# TERAFLEX

## Technical Service Bulletin JK HD Ball Joint Kit 2013+ JK Stub Shaft Modification

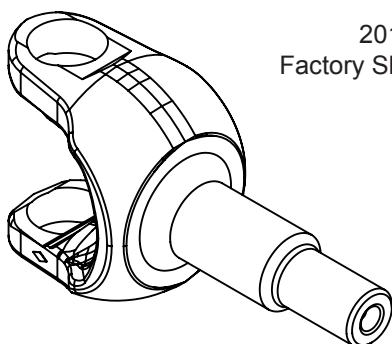
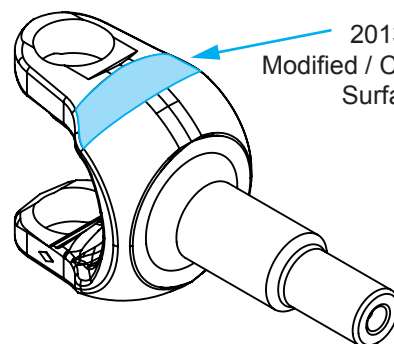
2013 and newer front Dana 30 & Dana 44 equipped JK Wranglers utilize a larger diameter outer stub shaft. This causes interference issues when used with TeraFlex HD Ball Joints (lower ball joint only).

Note: By avoiding any modification to the critical strength area, shown above, the outer stub shaft's performance and strength will not be affected by this slight modification.

A DIY solution to fix this issue involves minor clearing of a non-critical area of the outer stub shaft to allow proper lower ball joint clearance. As seen in the diagram above, removal of approximately 0.125" from each side of the outside diameter of the outer stub shaft shoulder is required.
